Access Compliance Report

Public Rights-of-Way

(Curb Ramps)

Intersection ID: N/A	Main Street: CANTERBURY CASTLE DR	Cross Street: SAGMORE HILL DR	Location: S
ADA ID: D336EDC0A7EF	Ramp Type: Perp	Initial Pass/Fail: Fail	Overall Compliance: No
Severity Score: 10			
Codes/Mitigation Info/Possible Solution		Field Measurements/Component Compliance

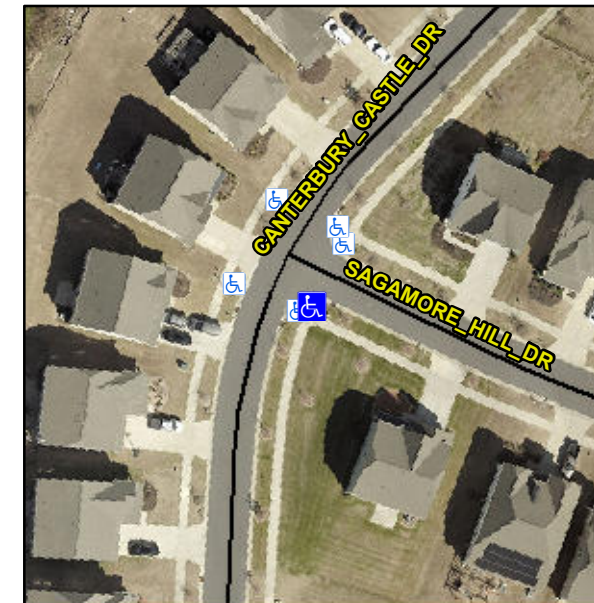
R304.5.1, R304.5.3

Compliance	Description	Data	Compliance	Description	Data
N/A	Ramp Length (in)	98.0	Yes	Ramp Slope (%)	6.7
No	Ramp Width (in)	45.0	No	Ramp XSlope (%)	4.2
N/A	Flare Type LT	N/A	N/A	Flare Type RT	N/A
N/A	Flare Slope LT (%)	N/A	N/A	Flare Slope RT (%)	N/A
N/A	Flare Traversable LT?	N/A	N/A	Flare Traversable RT?	N/A
N/A	Landing Length (in)	N/A	N/A	DWS Provided?	N/A
N/A	Landing Width (in)	N/A	N/A	DWS Contrast?	N/A
N/A	Landing Slope (%)	N/A	N/A	DWS Length (in)	N/A
N/A	Landing X Slope (%)	N/A	N/A	DWS Full Width?	N/A
N/A	Landing Curb? (Y/N)	N/A	N/A	DWS Offset (in)	N/A
N/A	Shared Landing?	N/A			
N/A	Gutter Ponding?	N/A	N/A	Gutter Slope (%)	N/A
N/A	Gutter Lip Ht (in)	N/A	N/A	Gutter X Slope (%)	N/A
N/A	Painted X Walk1?	No	N/A	Painted X Walk2?	N/A
	X Walk 1 Direction	To NE		X Walk 2 Direction	N/A
N/A	X Walk 1 Width (in)	N/A	N/A	X Walk 2 Width (in)	N/A
	X Walk 1 Slope (%)	0.8		X Walk 2 Slope (%)	N/A
	X Walk 1 X Slope (%)	3.0		X Walk 2 X Slope (%)	N/A

Remove & Replace Entire Ramp.
